SERVICE BULLETIN

TS-430S NOTCH CONTROL

11-07-83

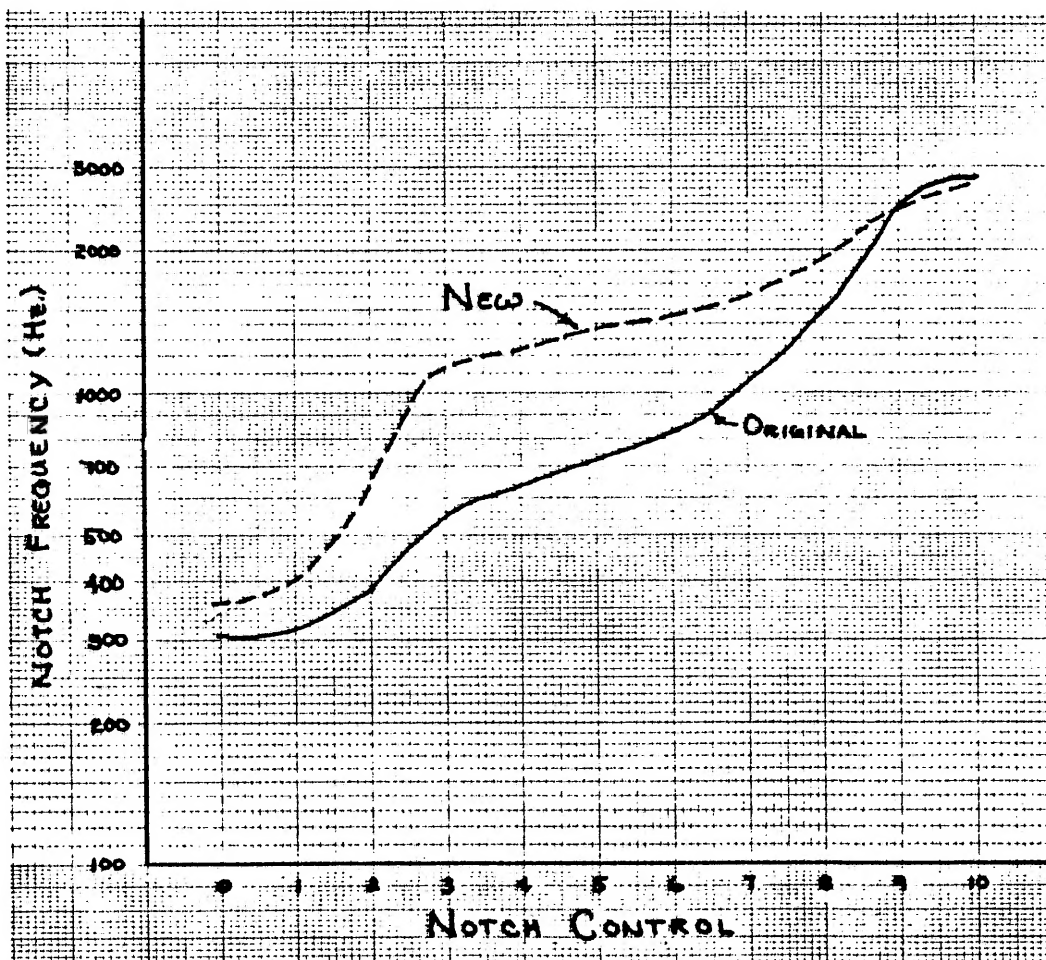
Notch/Squelch control (VR5) may be replaced with part number R24-9403-15, to allow greater flexibility in adjustment. As can be seen from the chart below, the curve is smoother on the high frequency side (1 kHz to 2.7 kHz), making tuning easier. VR5 is located on Switch unit (X41-1470-00).
